NOTICE TO RECIPIENTS OF MOONEY SERVICE BULLETINS M20-275 AND M20-276

SERVICE BULLETIN M20-276

SUBJECT: OVERHEAD TUBULAR STRUCTURE MODIFICATION

Figure M20-276-1

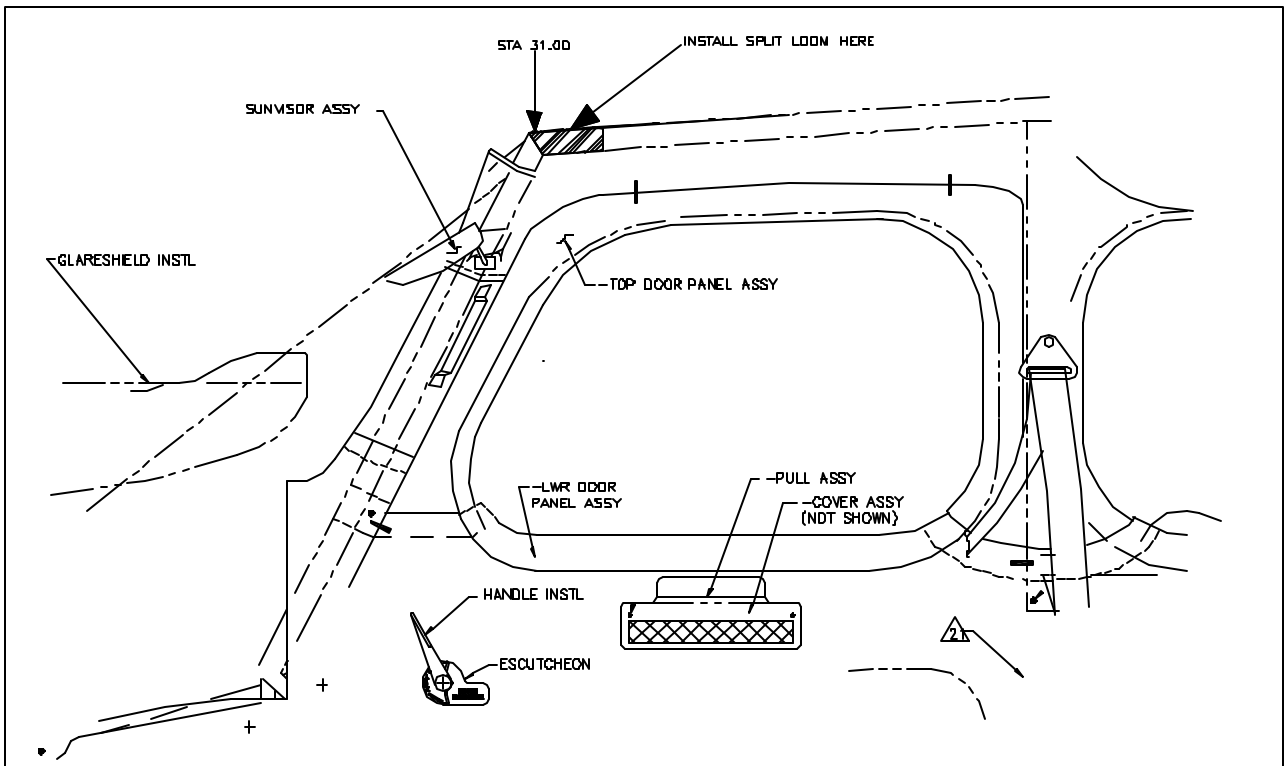
INTRODUCTION: It has been determined that the possibility of arcing between the headliner assembly bus bar (associated with the overhead light switches) and the overhead tubular structure exists in the affected aircraft. This service bulletin provides for inspection of the overhead area and installation of split loom tubing over part of the overhead tubular structure to prevent inadvertent arcing from either of the headliner assembly bus bars.

2. Drop headliner assembly down far enough to access overhead tubular structure (figure
- 3.
